<b>Subject:</b>  MIL ILLUMINATED - P0455 SET	<b>Bulletin No:</b> 01-040/09
	<b>Last Issued:</b> 10/05/2009

## BULLETIN NOTE

- This bulletin supersedes the previous bulletin 01-020/07 issued on 05/24/07 and 5/25/07 and 01-040/09 issued on 9/16/09 and 10/02/09. The WARRANTY INFORMATION has been revised.
- Changes are noted below in Red beside the change bar.

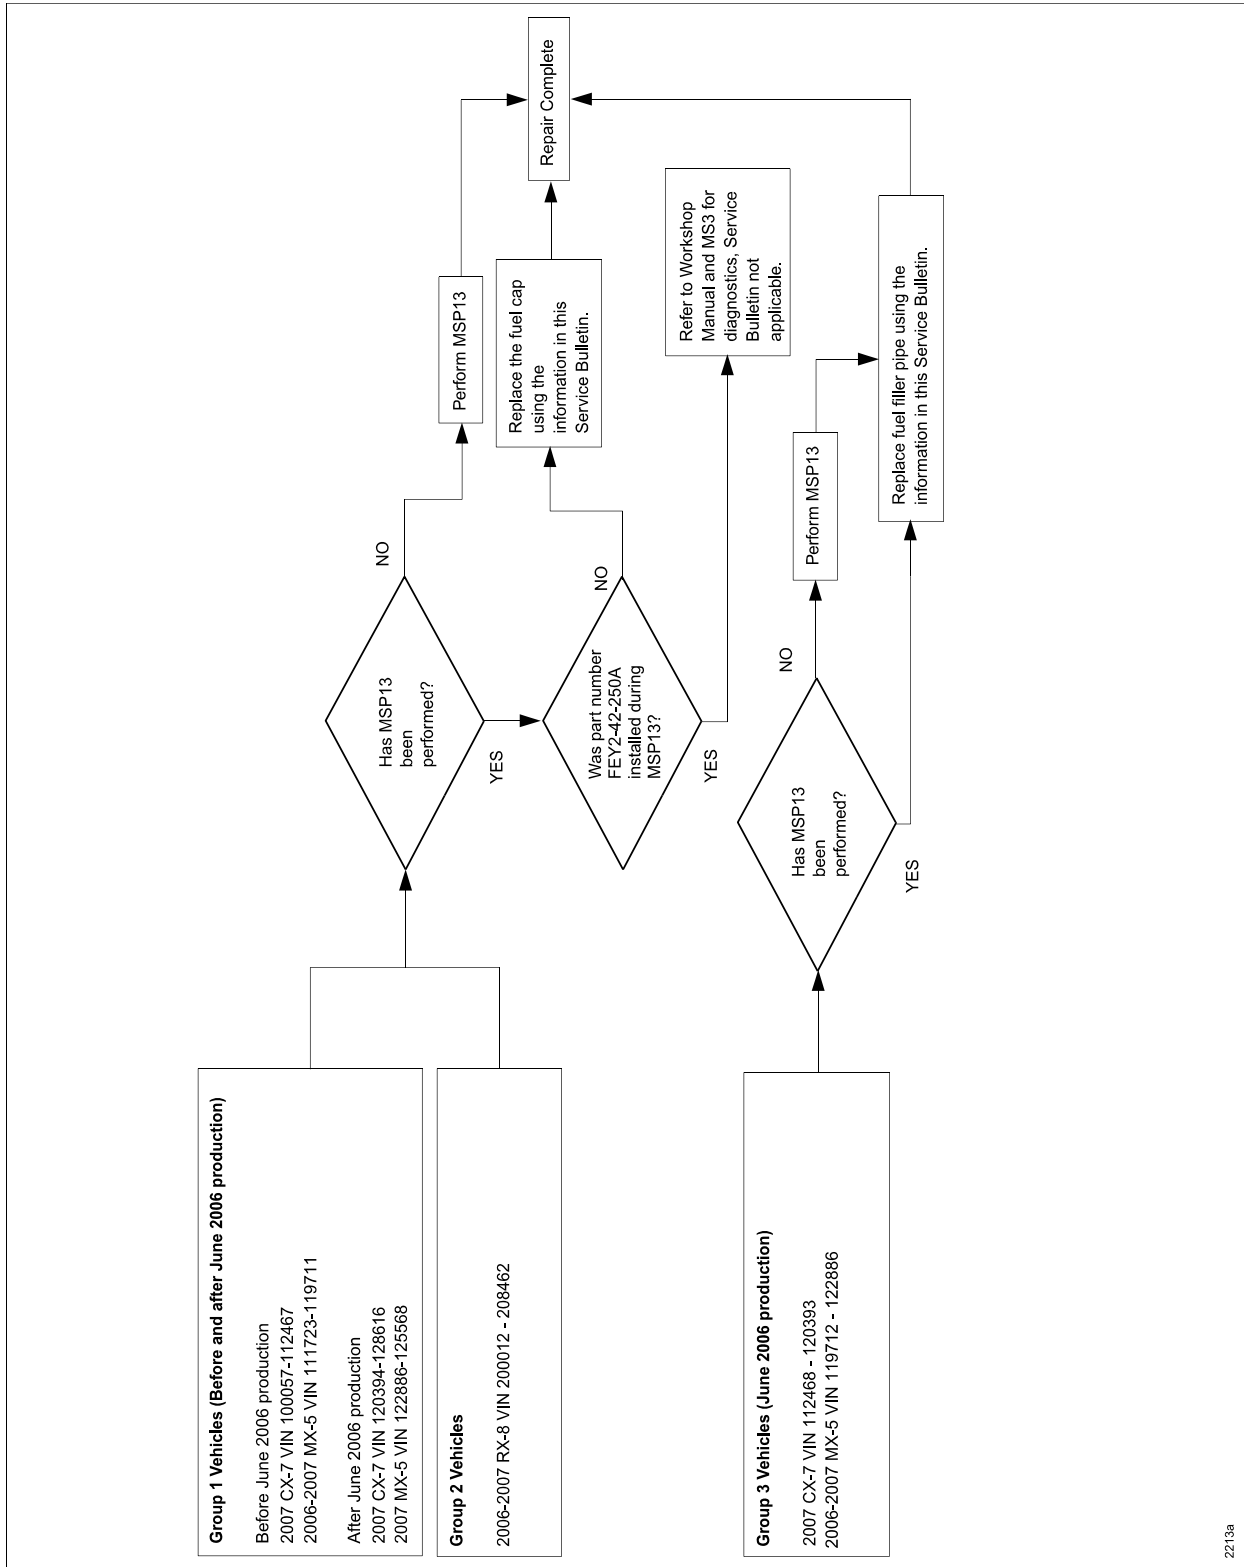
Some fuel filler pipes may be out of specification and in some cases, may not allow the fuel filler cap to be fully tightened. As a mass-production change, the fuel filler pipe and the fuel cap have been modified. Depending on the vehicle VIN range, either the fuel filler pipe and/or fuel cap may need to be replaced.

Customers having this concern should have their vehicle repaired using the following flow chart and repair procedure.

1. Verify customer concern.
2. Perform MSP13 and/or replace the fuel cap or fuel filler pipe according to the chart. For fuel filler pipe, refer to MS3 online instructions or Workshop Manual section 01-14 FUEL TANK REMOVAL / INSTALLATION.
3. Verify repair.
